ADMINISTRATIVE AMENDMENT (PD) ADD2002-00006

ADMINISTRATIVE AMENDMENT
LEE COUNTY, FLORIDA

COCONUT SHORES VILLAS

SITE PLAN

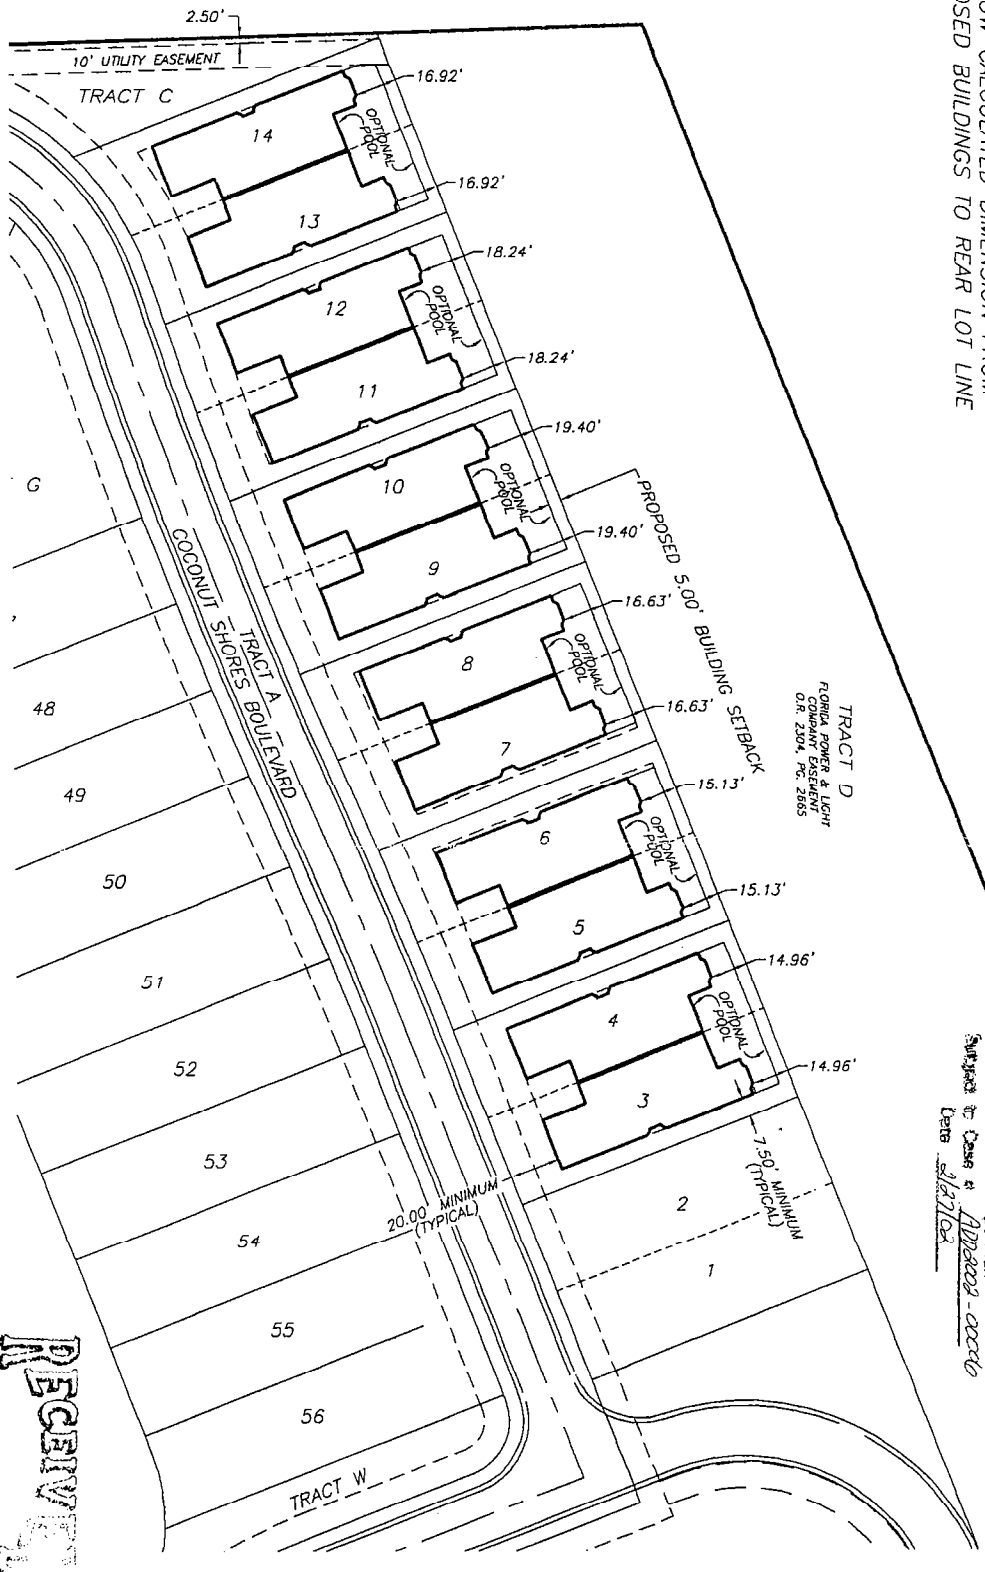
WHEREAS, the approval requested approval would amend the planned development to **allow a reduction in the required minimum rear yard setback of 20 feet to between 14.96 feet and 19.4 feet for the principal structure and to 5 feet for pool/jacuzzi** on properties located at 23245, 23241, 23235, 23231, 23225, 23221, 23215, 23211, 23205, 23201, 23195, and 23191 Coconut Shores Drive, which properties are more particularly described as:

WHEREAS, the proposed rear yard setbacks for the principal building are based upon a drawing showing the layout of actual proposed units for each of the lots in question, and

NOW, THEREFORE, IT IS HEREBY DETERMINED that the application for administrative approval for an amendment to Residential Planned Development is **PARTIALLY APPROVED. Specifically, the rear setback amendment from 20 feet to between 14.96 feet and 19.4 feet for the principal structure is APPROVED as conditioned in the following and the proposed accessory structure setback is DENIED.**

1. **The Development must be in compliance with the amended Master Concept Plan, dated 12-11-2001, as prepared by Trask Associates, Inc., and stamped received on January 25, 2002. Master Concept Plan for ADD2002-00006 is hereby APPROVED and adopted. A reduced copy is attached hereto.**

3. **This amendment only is effective for Lots 3 through 14 of the Coconut Shores Subdivision, as recorded in Plat Book 65, Page 29.**

4. **All residential accessory uses must comply with the required setbacks of the Lee County Land Development Code.**
